**Flood Control Project Maintenance
Levee Inspections****LMA District Cover Sheet****Spring 2015 Levee Inspection Results****Lake County Watershed Protection District**

Levee Inspection Report By Mile - Spring 2015

Lake County Watershed Protection District

Photo 1 of 1 : SP_2015_NA0009_3_14_20150310_00008.jpg

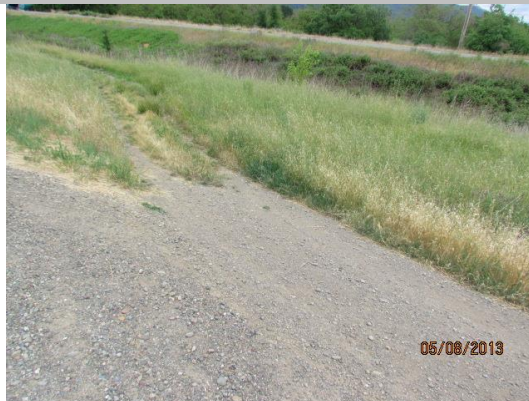
LM Start	2.36	Rating **	M	Issue No.	14
LM End	2.36	Issue Type +	Ma	Location *	WS
Category	Earthen Levee			GPS Latitude/Longitude	
				Start	End
Item	Slope Stability			39.161153 °	39.161153 °
				-122.912740 °	-122.912740 °
DWR ID	DWR_NA0009_01_s _ 2013_14				
Action/Comments					
Repair the levee slope damaged by vehicle traffic and prevent access where possible.

View of the vehicle erosion along the waterside slope.
